ATTACHMENT 2

Letter from C. R. Steinhardt (WPSC)

June 28, 1991

PROPOSED TS AMENDMENT NO. 103

FIGURE TS 3.1-3

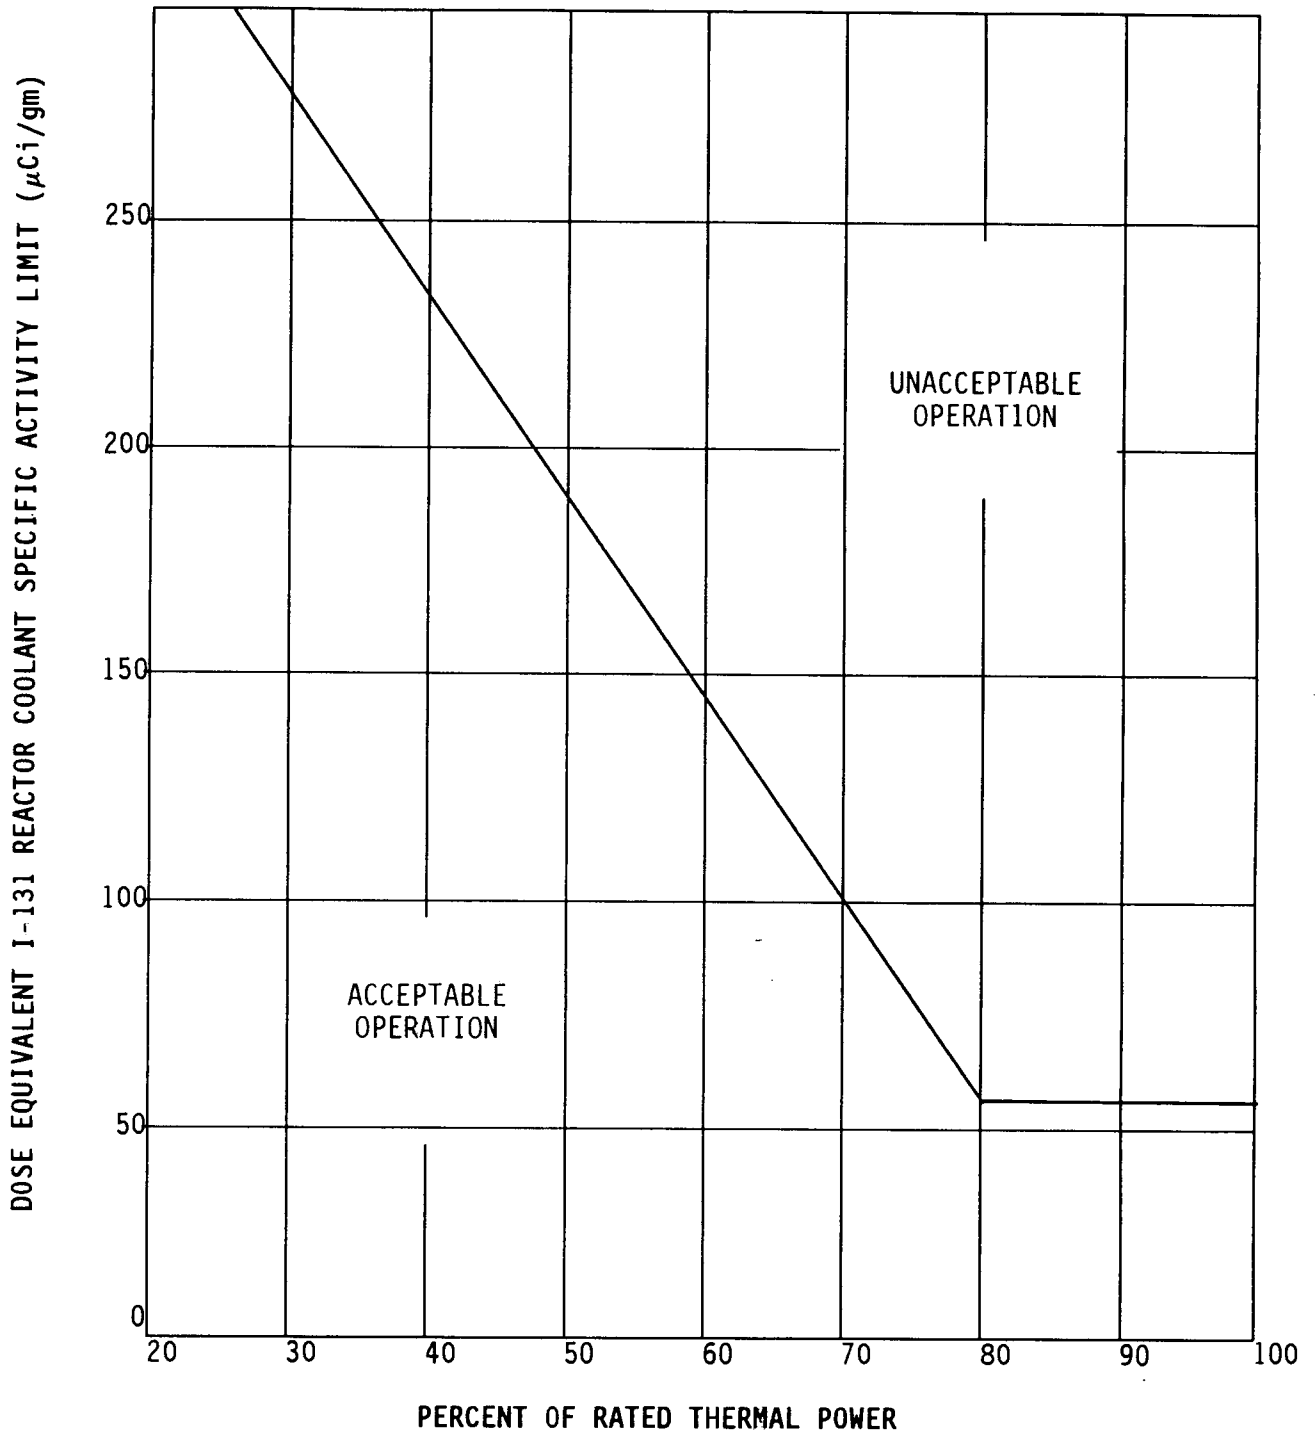
A. With the specific activity of the reactor coolant  $> 1 \mu\text{Ci}/\text{gram DOSE EQUIVALENT I-131}$  for more than 48 hours during one continuous time interval, or exceeding the limit shown on Figure TS 3.1-3, be in at least INTERMEDIATE SHUTDOWN with an average coolant temperature of  $< 500^\circ\text{F}$  with 6 hours.

The action statement permitting power operation to continue for limited time periods with reactor coolant specific activity  $> 1 \mu\text{Ci/grams DOSE EQUIVALENT I-131}$ , but within the allowable limit shown in Figure TS 3.1-3, accommodates the possible iodine spiking phenomenon which may occur following changes in thermal power.
